Subject: GS Pin Slider Modification

Distribution: All GS Pinsetter Customers

Letter No. CEB01-3

Figure 1

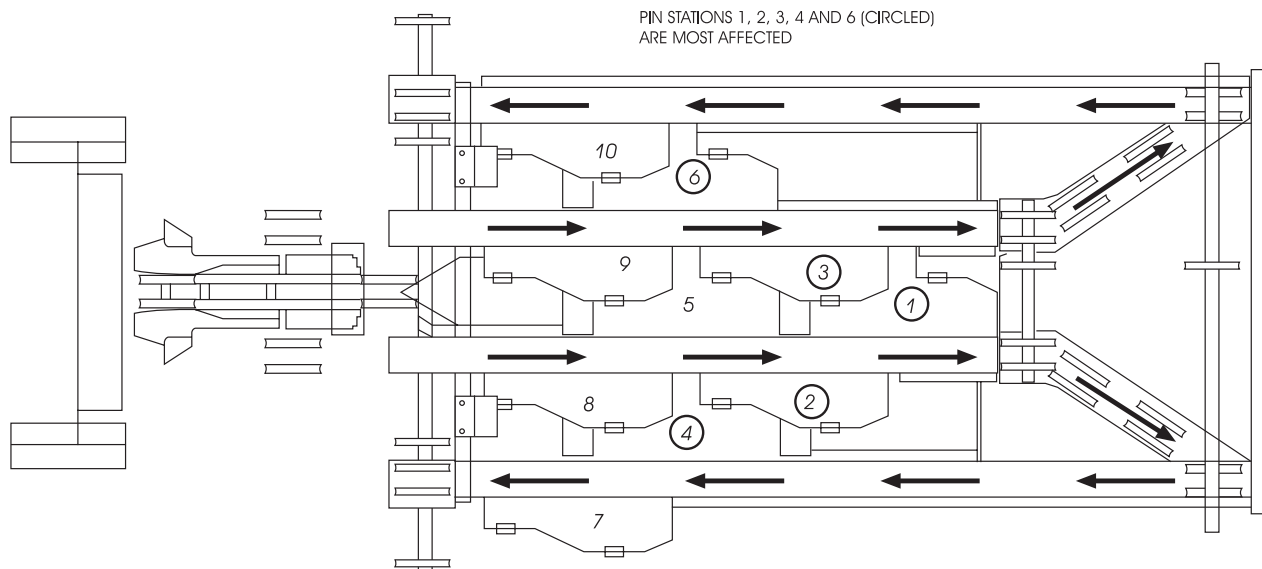
A number of customers with GS Pinsetters containing the gray and black pinholder assembly have reported problems with pins shooting forward when they are loading into pinholder. This causes the pin to not be correctly located in the pinholder and therefore to not activate the switch in the pinholder. In some cases the pin will shoot completely forward and fall out of the front of the pinholder.

The pin positions most affected with this condition are positions 1, 2, 3, 4 and 6. Refer to Figure 1.
